F/CMVSS Noncompliance Recall

17035 Front Seat Discrepant Welds on Manual Recliner Bracket

Reference Number: N162075000

Revision: 01

4691240

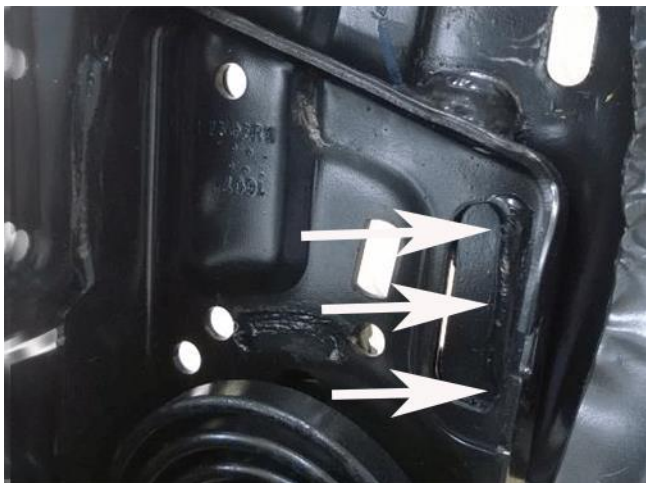
Unacceptable Condition, Holes Off-Center

9. If any of the welds or alignment holes are not correctly positioned, replace the seat back cushion frame. Refer to *Driver or Passenger Seat Back Cushion Frame Replacement* in SI.
10. Reinstall all of the seat trim.
11. Perform steps 1-10 on the driver side manual seat if equipped. Do not remove, disassemble or replace the seat frame of a power seat assembly.
12. Reinstall the seat(s). Refer to *Driver or Passenger Seat Removal and Installation* in SI.

4690702

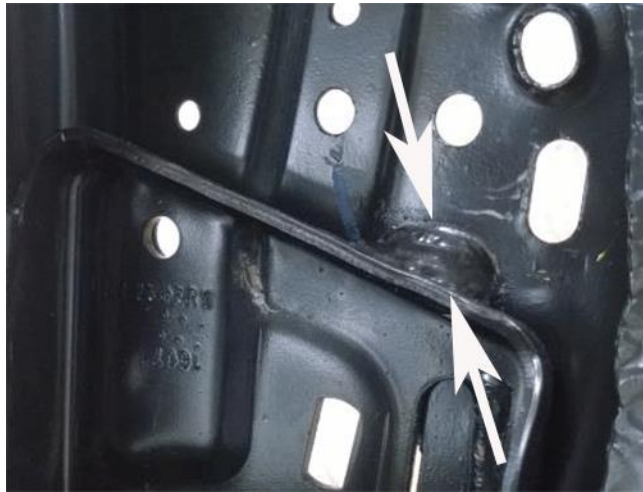
8. Inspect the inner and outer recliner bracket to seat frame weld locations. There are three welds per side. Ensure the weld is located on the edge of the bracket and connects to the seat frame.

- **Weld location in weld slot**

4690706

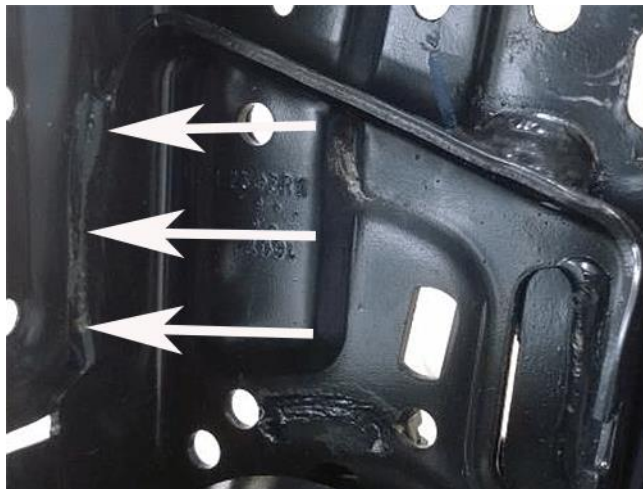
- Weld located on top edge
